REMARKS

This paper is in response to the Office Action mailed on 09/21/2004. In the Office Action, claims 51-65 and 106-112 were rejected under 35 U.S.C. § 102(e). Reexamination and reconsideration in view of the amendments and the remarks made herein is respectfully requested.

I) Drawing Amendment

FIG. 16

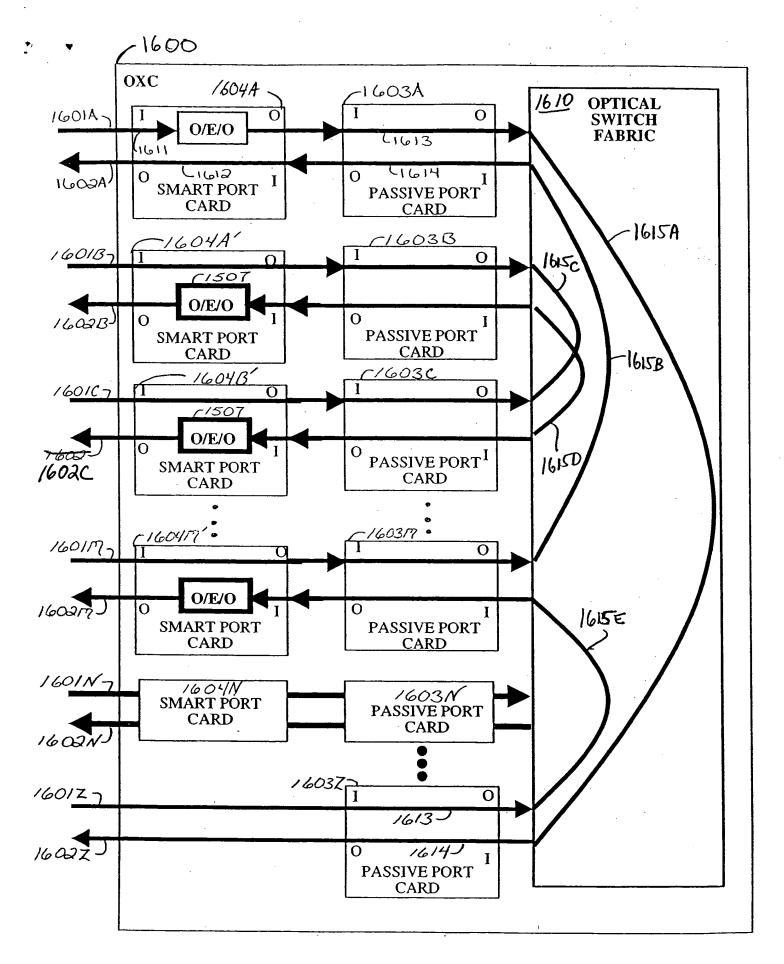
In Figure 16, Applicant has corrected the reference number "1602" to --1602C--.

The reference number 1602 was inconsistent with the specification.

Applicant has amended the drawing of Figure 16 by changing the reference number "1602" therein to --1602C--.

An annotated version of amended Figure 16 is attached hereto as Appendix II to indicate this change in red.
